APPEAL SUMMARY

| Appeal ID: 23491 | Project Address: 3920 N Montana Ave |
| Appeal Involves: Erection of a new structure | LUR or Permit Application No.: 19-216573-CO |

Code Section 1022.1

SHEET TITLE:
1st FLOOR PLAN

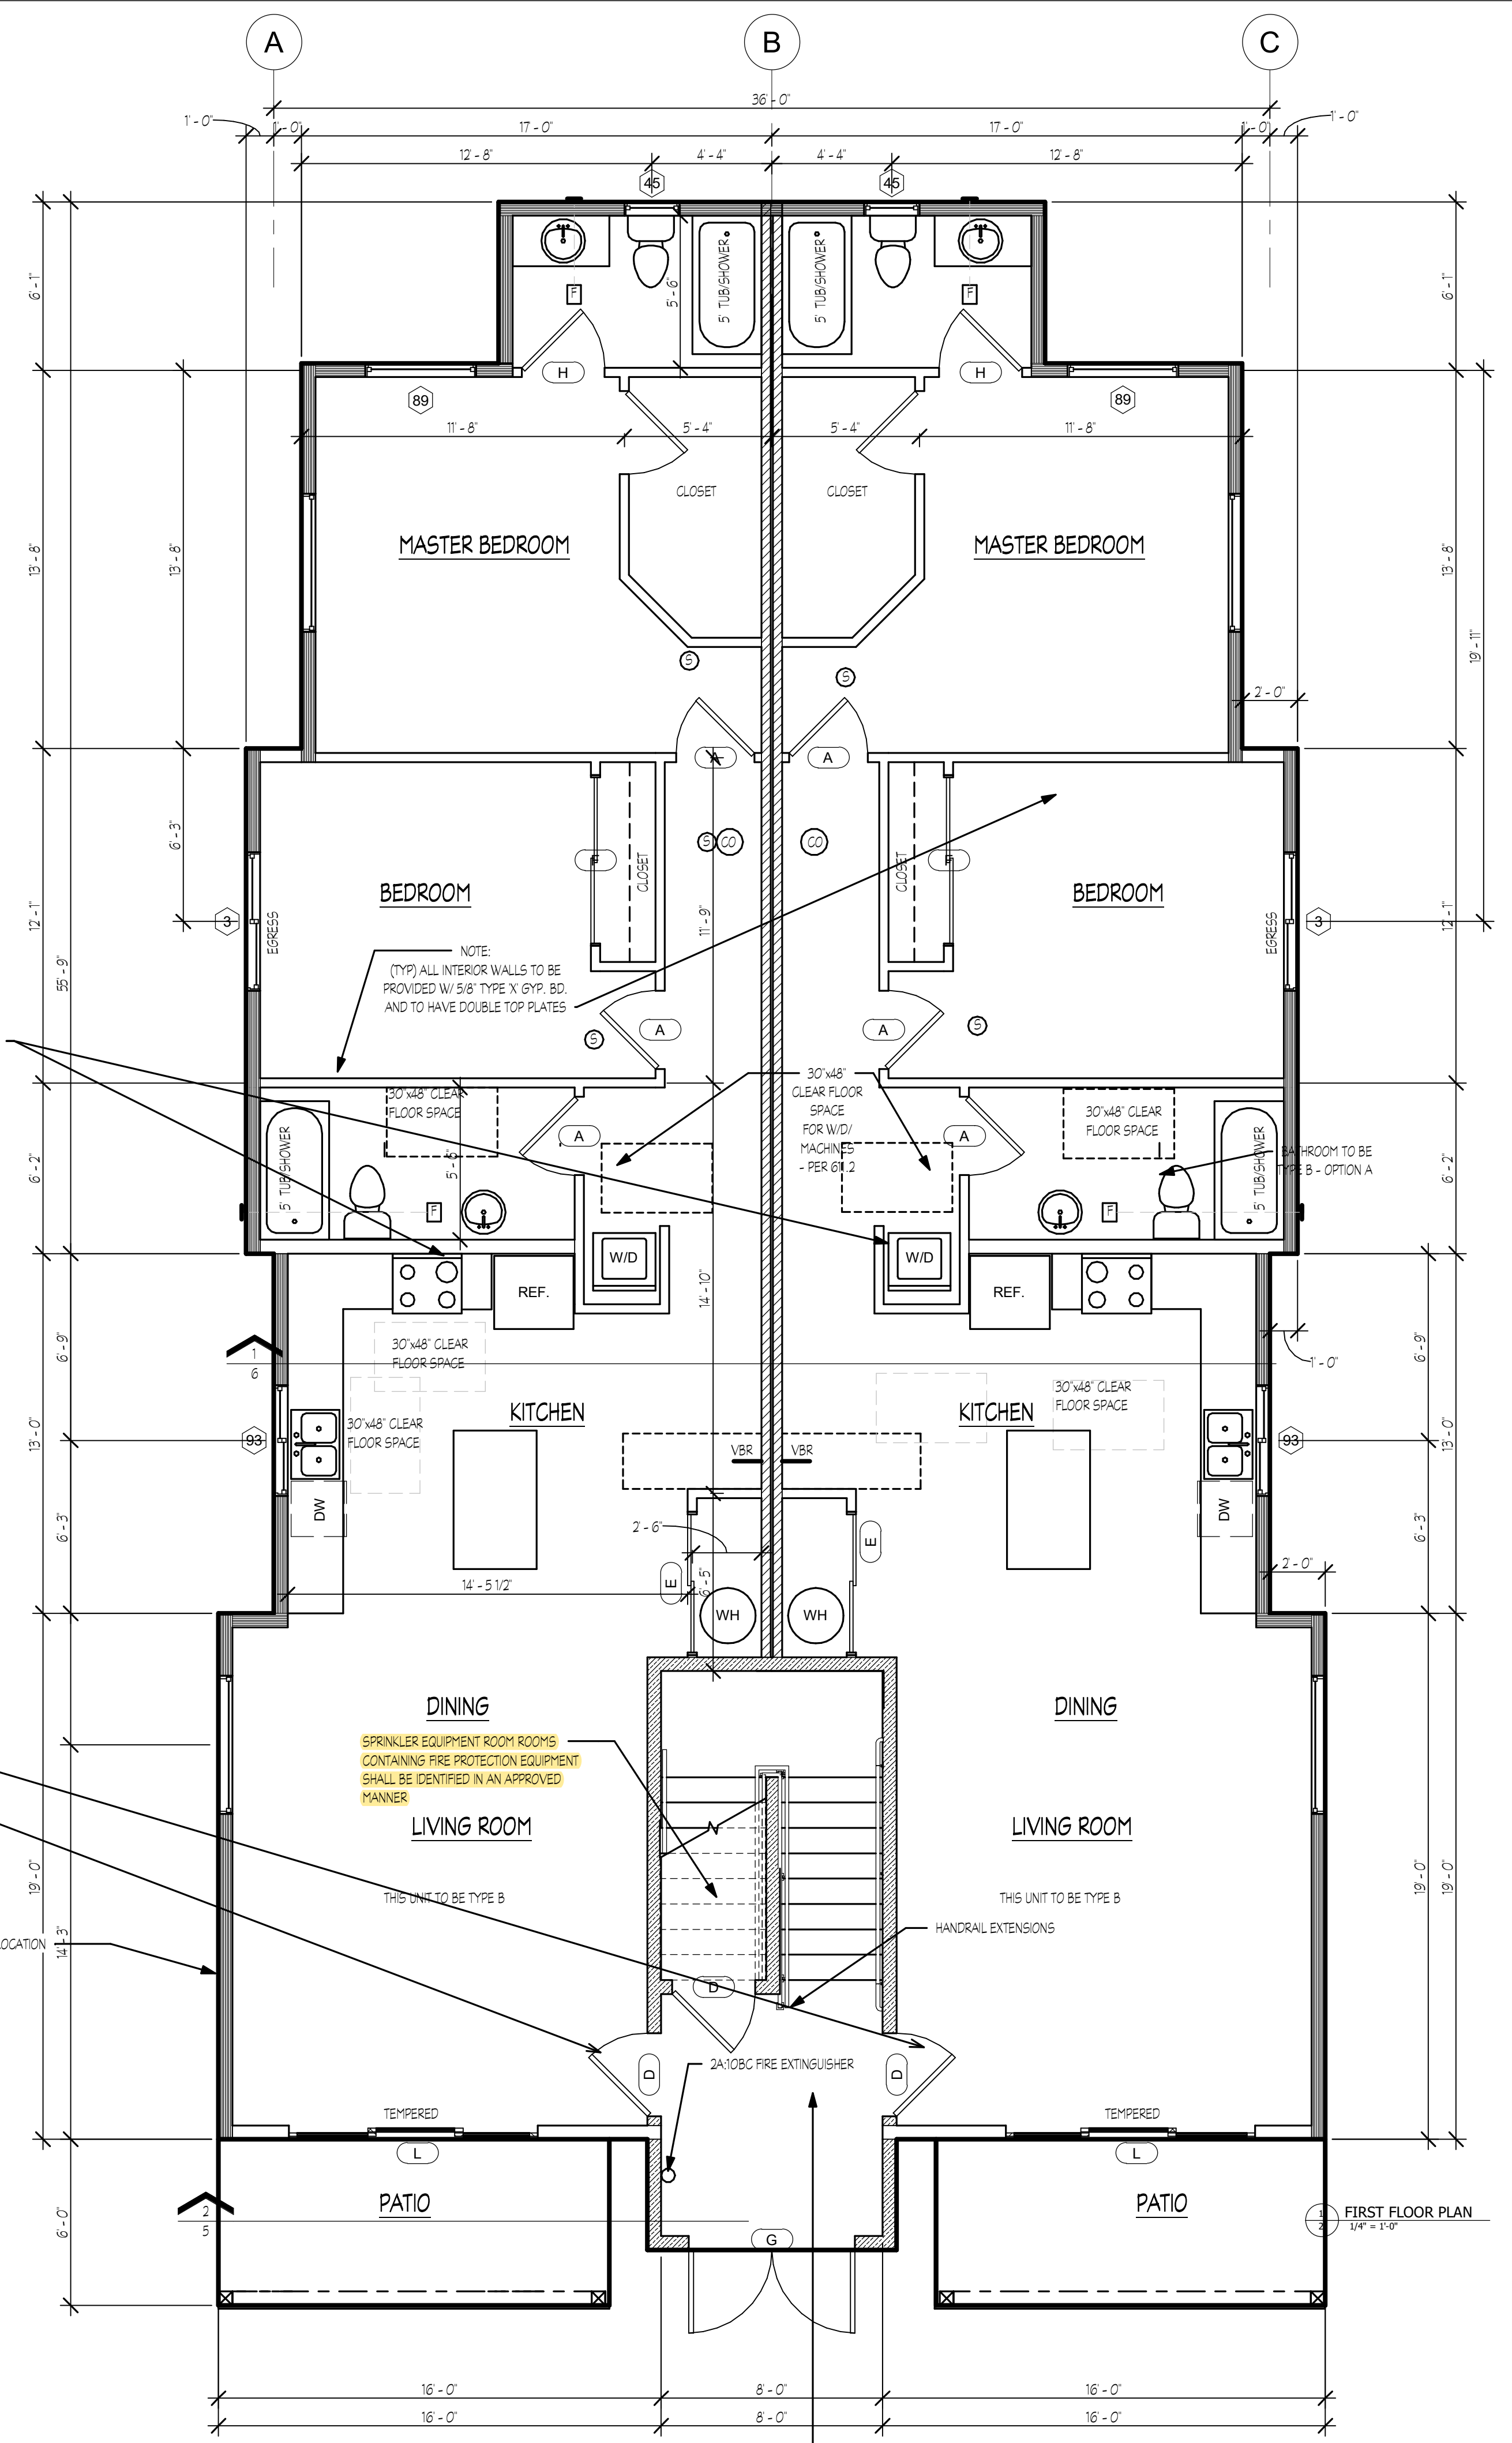
Requires Interior Exit Stair shall not be used for any purpose other than means of egress.

Code Modification or Alternate Requested intend to have the fire sprinkler room under the stair.

Proposed Design I am intending to have the fire sprinkler room under the stair using a fire rated door and all walls to be 1hour rated.

Reason for alternative Because the location that I propose to use for the fire sprinkler will not interfere with accessibility in and from the building, will not alter any structural capacity, energy efficiency nor create any health problem.
By allow me to build the fire sprinkler room on this location, using fire rated walls and fire rated door will decrease the foot print of the building and be more secure.

Access to fire sprinkler room from within interior exit stair enclosure: Granted provided signage is posted prohibiting storage in sprinkler room.
